Access Compliance Report

Public Rights-of-Way

(Curb Ramps)

Intersection ID: 7375	Main Street: N_TRYON_ST	Cross Street: TOM_HUNTER_RD	Location: NW
ADA ID: 47A715D8B96B	Ramp Type: MedianPerp	Initial Pass/Fail: Fail	Overall Compliance: No
		Severity Score: 12.5

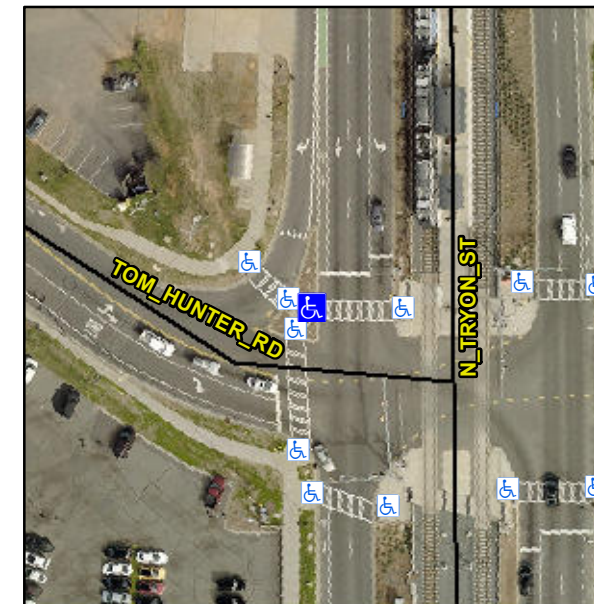
R304.2.2

Compliance	Description	Data	Compliance	Description	Data
N/A	Ramp Length (in)	71.0	No	Ramp Slope (%)	8.9
Yes	Ramp Width (in)	91.0	Yes	Ramp XSlope (%)	0.9
N/A	Flare Type LT	N/A	N/A	Flare Type RT	N/A
N/A	Flare Slope LT (%)	N/A	N/A	Flare Slope RT (%)	N/A
N/A	Flare Traversable LT?	N/A	N/A	Flare Traversable RT?	N/A
N/A	Landing Length (in)	N/A	N/A	DWS Provided?	N/A
N/A	Landing Width (in)	N/A	N/A	DWS Contrast?	N/A
N/A	Landing Slope (%)	N/A	N/A	DWS Length (in)	N/A
N/A	Landing X Slope (%)	N/A	N/A	DWS Full Width?	N/A
N/A	Landing Curb? (Y/N)	N/A	N/A	DWS Offset (in)	N/A
N/A	Shared Landing?	N/A			
N/A	Gutter Ponding?	N/A	N/A	Gutter Slope (%)	N/A
N/A	Gutter Lip Ht (in)	N/A	N/A	Gutter X Slope (%)	N/A
N/A	Painted X Walk1?	Yes	N/A	Painted X Walk2?	N/A
	X Walk 1 Direction	To E		X Walk 2 Direction	N/A
N/A	X Walk 1 Width (in)	106.0	N/A	X Walk 2 Width (in)	N/A
	X Walk 1 Slope (%)	2.1		X Walk 2 Slope (%)	N/A
	X Walk 1 X Slope (%)	0.3		X Walk 2 X Slope (%)	N/A

Remove & Replace Entire Ramp.
